October 2, 2014

Updated January 7, 2021

RE: LINKSVIEW DEVELOPMENT / BLUE MOUNTAIN GOLF & COUNTRY CLUB

You have requested that we review our original report, as it related to the most recent development concept plan prepared by MHBC.

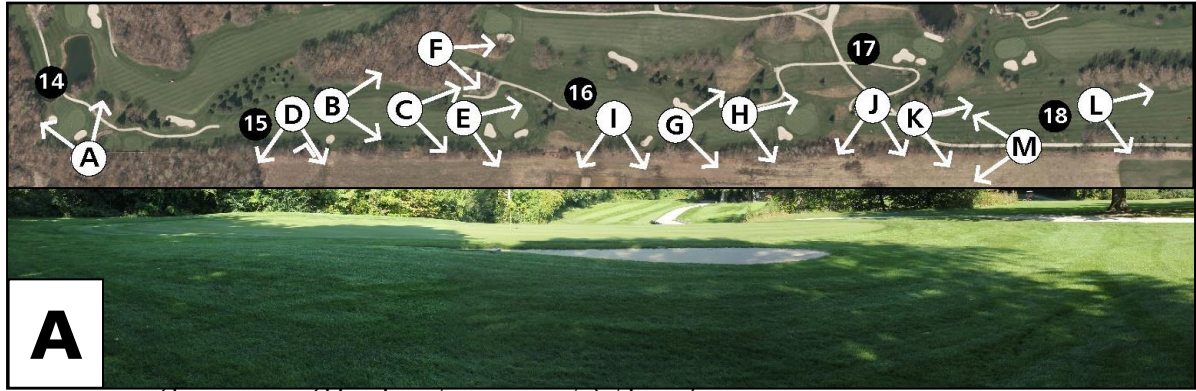
15th Tee

16th Green Near Property Line

Woodlot Edge

Out of Bounds

Hedgerow (typical)

Dense Hedgerow Edge Near Tee

15th Green Near Property Line

Additional Tree Planting on 18th Hole

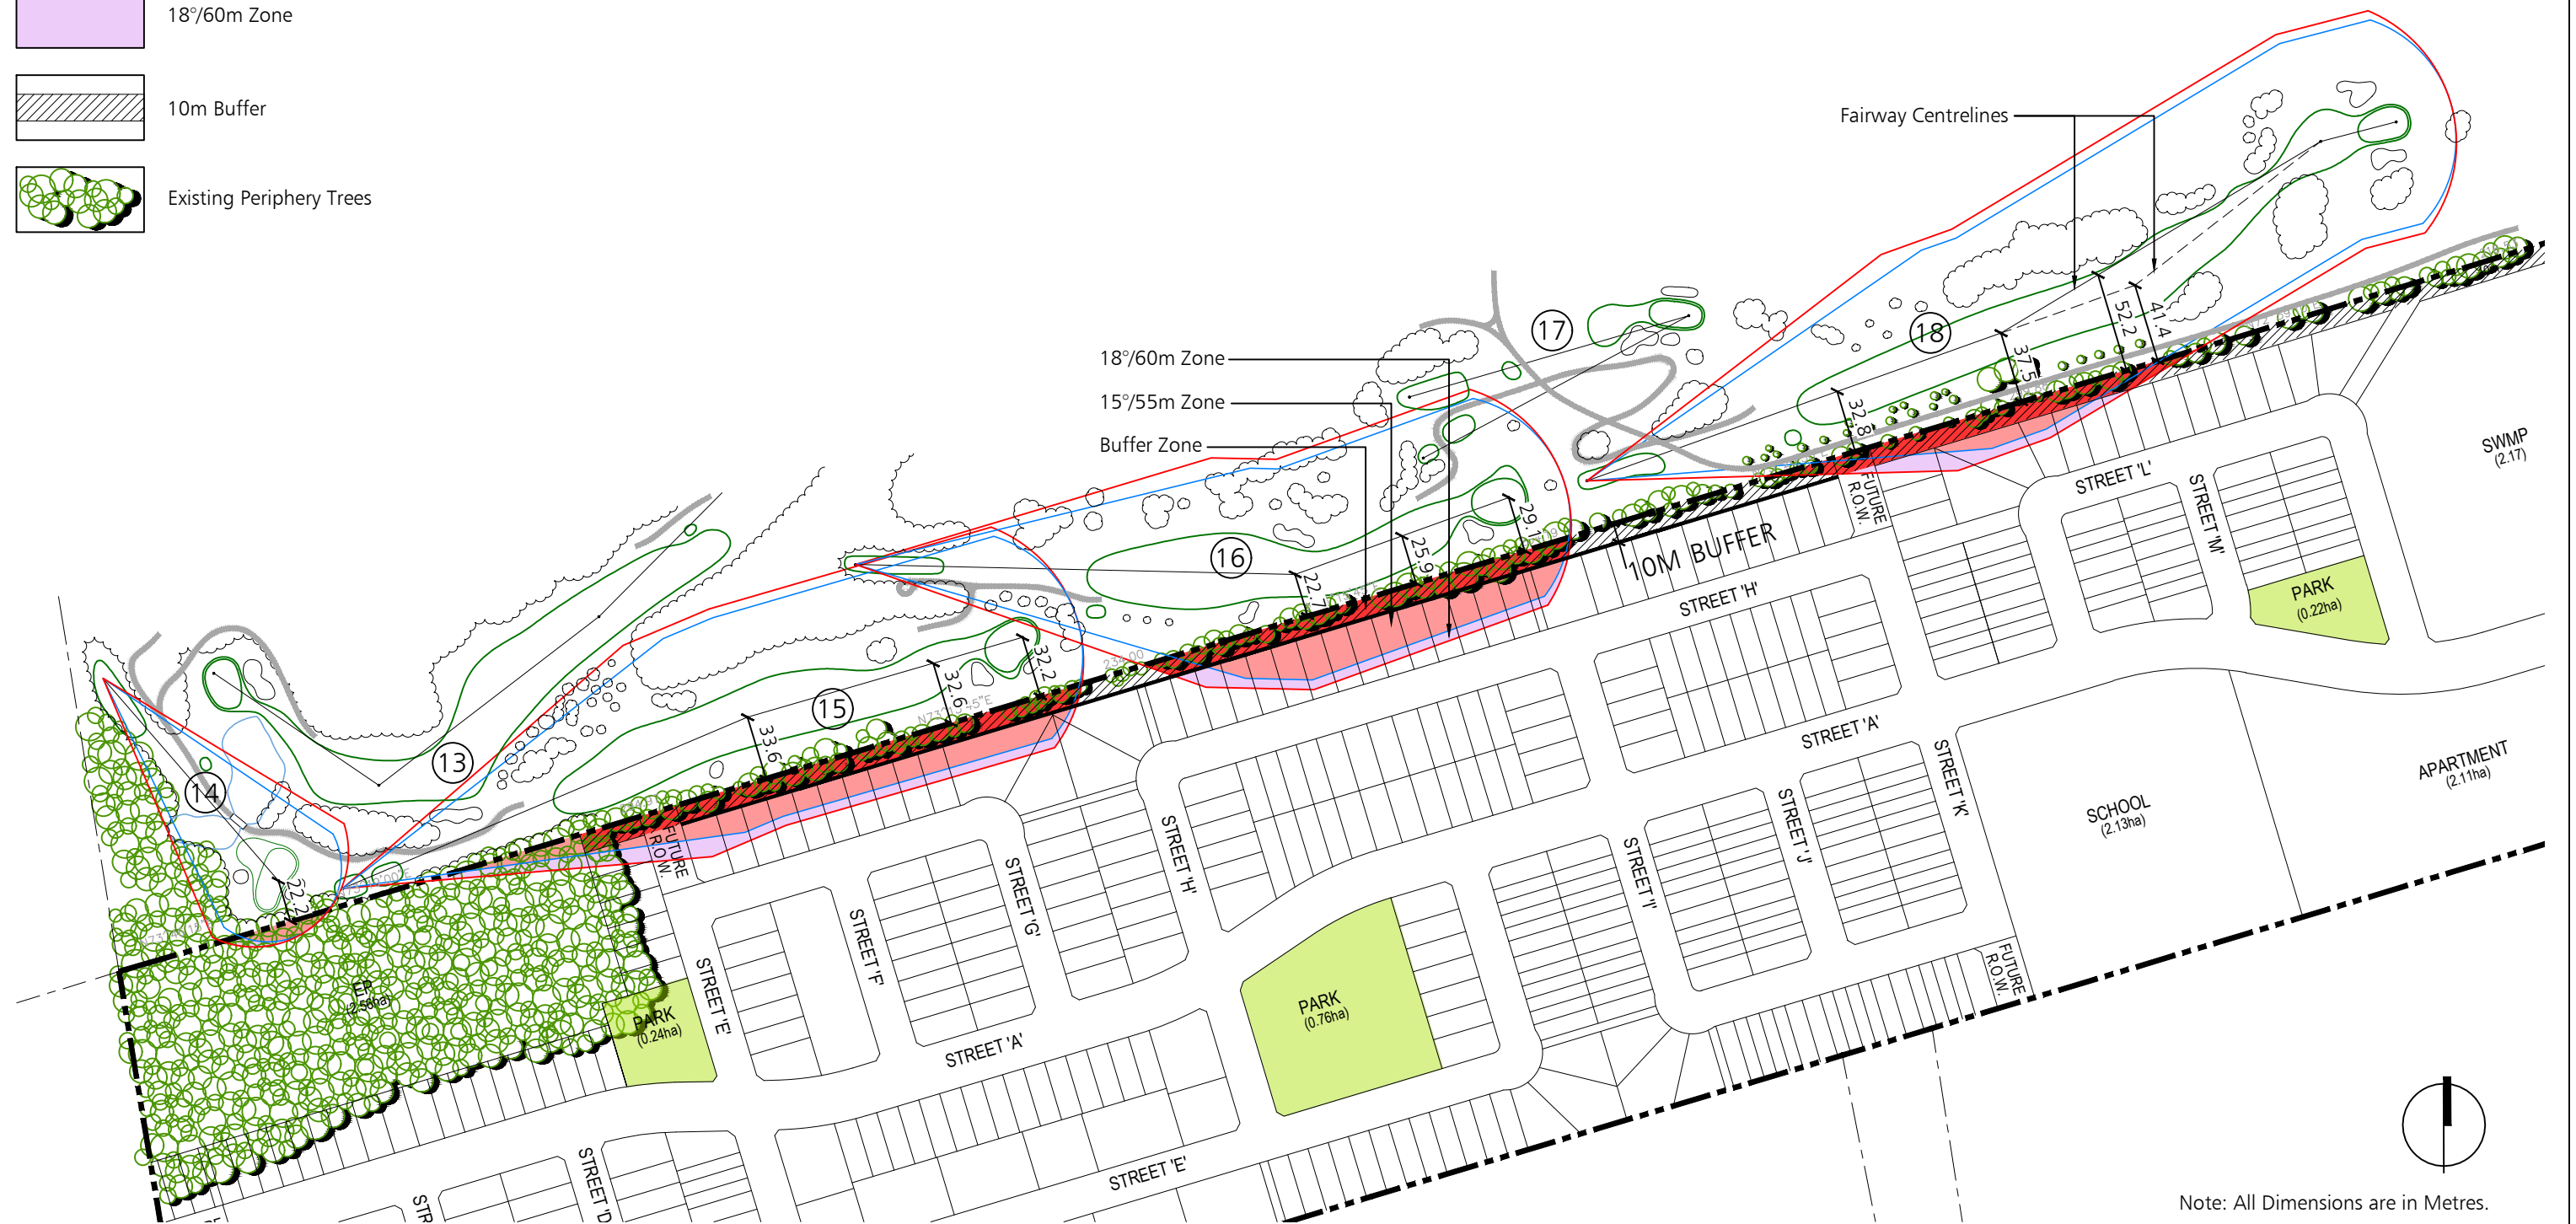
This hole is a par 3 with a maximum length of 166 yards. It plays at a right angle to the southern boundary. The safety envelope extends approximately 15 metres into the woodlot. A buffer zone is not planned for this area.

This hole plays parallel to the property line. The tee is located immediately adjacent to the woodlot which intercepts most errant shots towards the right side. The hedge row provides additional mitigation for most of the hole's length. The proximity of the fairway and the green to the south property boundary none the less still presents danger to the proposed residential lots.

This hole plays diagonally towards the existing southern boundary of the property. The current landing area centre line is 22.7 metres from the property line. The centre of the green is 29.1 metres from the property line. The hedgerow at this point is sporadic, varying from low dense, thick shrubs to trees up to 12 metres in height.

This hole is a long par 5. The tee and the centre line of play is 37.5 metres from the property line. From the first landing area the hole plays diagonally away from the property line. While the hedge row is sporadic, approximately 30 trees have been planted adjacent to the property line.

Recommendations: The density of the trees and the proposal to maintain the woodlot as nature preserve provides sufficient mitigation.

Recommendations: The centre line of play from the tee should be directed further away from the property line. The fairway and green should be relocated approximately 60 metres away from the southern edge of the proposed buffer.

Recommendations: The centre line of the hole from the tee should be moved left and the fairway redefined accordingly. The green and the centre line of the fairway should measure 60 metres from the southern edge of the proposed buffer.

Recommendations: The tee should be relocated directly adjacent to the property line and the hole directed away from the property line. The centre line of play should be relocated 60 metres from the southern edge of the proposed buffer.
